ARCHITECTURE PLANNING URBAN DESIGN

July 20, 2022

**RE: 16220 Harwood Road: Parcel B**

*PROPOSED FRONT ELEVATION*

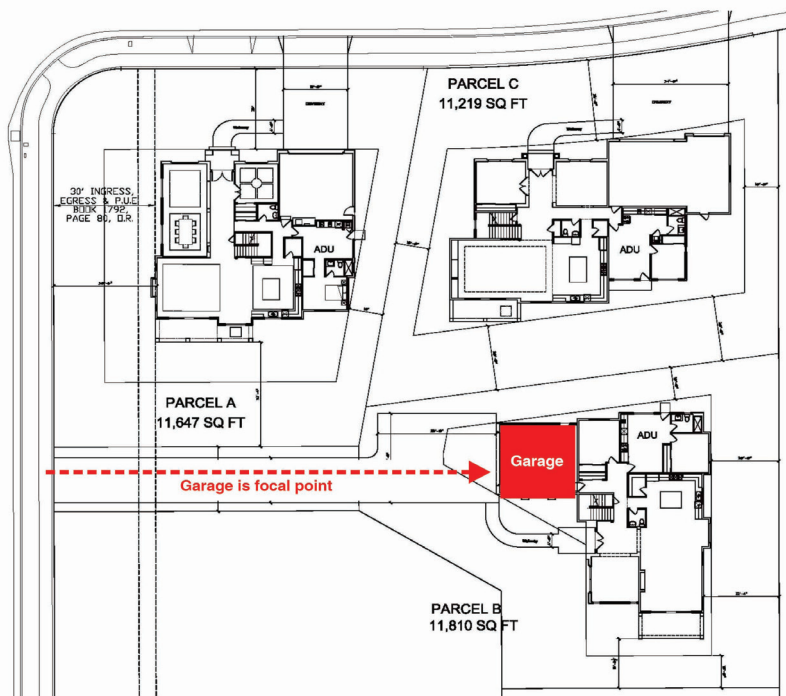
The two-story home is designed in a traditional architectural style - see proposed elevation illustrations below.

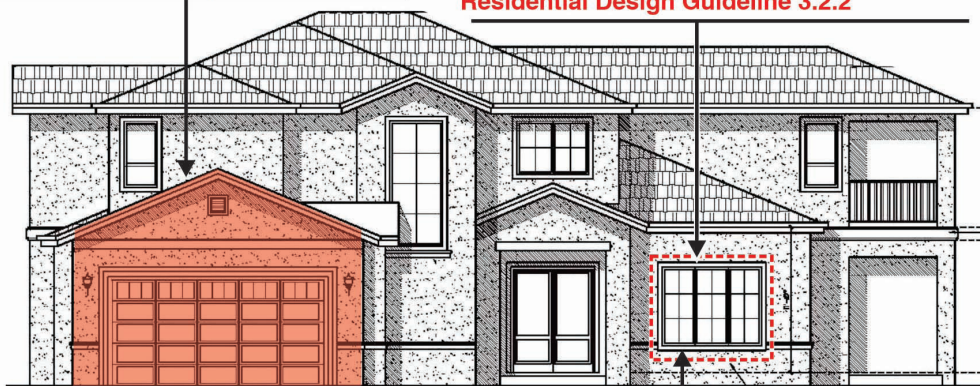
1. The constraints imposed by the setbacks on this parcel will result in the garage being the most prominent feature of the home relative to the street frontage and the entry drive which would not be consistent with Residential Design Guideline 3.4.1.

Garage as focal point from street and driveway is not desirable

Use of divided lite windows on the front elevation without continuing them around all sides of the house is not consistent with Residential Design Guideline 3.2.2

Window sill relationship to molding may be an issue  
- see Parcel A comment and recommendation

1. Add a trellis over the garage consistent with Residential Design Guideline 3.4.1 - see examples below.

### 3.2.2 Design for architectural integrity

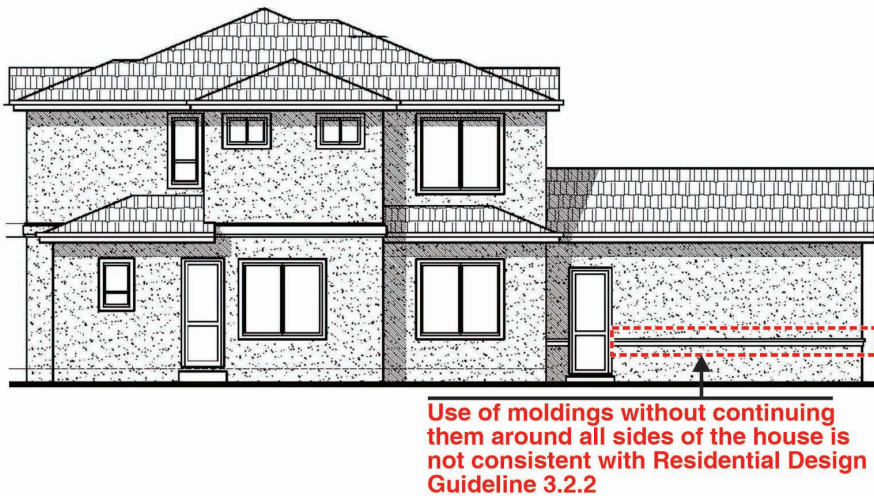
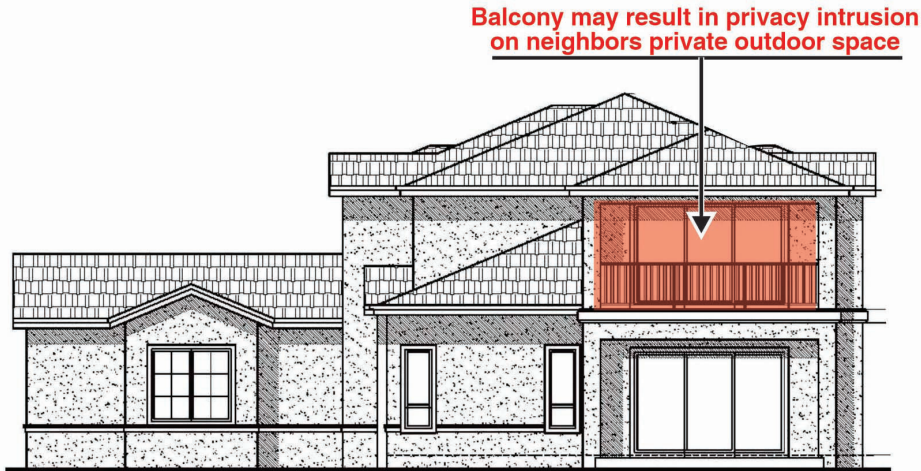
2. The divided lite windows and molding on the front of the house are not carried fully around the other three facades which is not consistent with Residential Design Guideline 3.2.2.

3. There may be an inconsistency between the window sill and molding height relationship on the front facade - see Parcel A review letter.
4. The second floor balcony off of the Master Bedroom may pose a privacy issue concern with views into the neighboring parcels private outdoor spaces.

2. Eliminate the second floor balcony or as a minimum fill in the balcony railing area with wall on all three exposed sides.
3. Continue the divided lite windows and projecting wall trim around all sides of the house.
